REMARKS

Applicant: N. Yasunishi, et al
U.S.S.N.: 09/748,502
Page 22

CONVENTIONAL
ART**FIG. 14A****FIG. 14B**

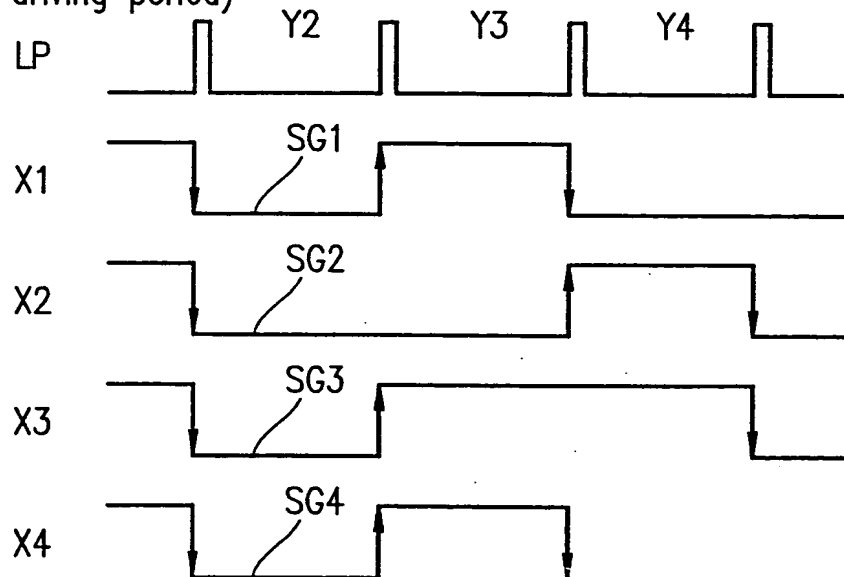
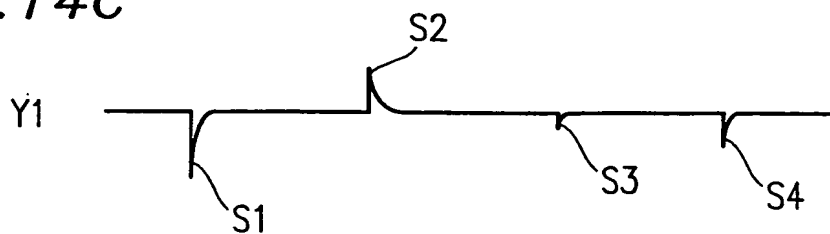
3. Provided Applicants with a Notice of References Cited (Form PTO-892) along with copies of the cited references;
4. Indicated that the drawings filed as part of this application are objected to on the basis that Figures 14A, 14B, 14C and 15 should be designated by a legend such as - PRIOR ART --, since only that which is old is illustrated therein - **Applicant respectfully requests that the foregoing Request for Drawing Change Approval be granted and that the new formal drawings submitted concurrently herewith be entered into this case in substitution for the corresponding sheets of drawing as originally filed in response to the Examiner's objection;**

With respect to item 4, Applicants respectfully call the Examiner's attention to the foregoing Request for Drawing Change Approval, the attached photocopies of Figs. 14 A, 14B, 14c and 15 of the present application whereon the proposed addition of the legend -- CONVENTIONAL ART -- is shown in red, and to the concurrently filed new set of formal drawings that include the changes proposed by Applicants. In the above regard, Applicants respectfully submit that since the specification characterizes the showings of Figs. 14A, 14B, 14C and 15 as "conventional", as opposed to admitting the statutory prior art status thereof, the proposed legend -- CONVENTIONAL ART -- is appropriate in the present circumstances to remove the basis of the Examiner's objection to the drawings. A decision so holding in response to this communication is respectfully requested.
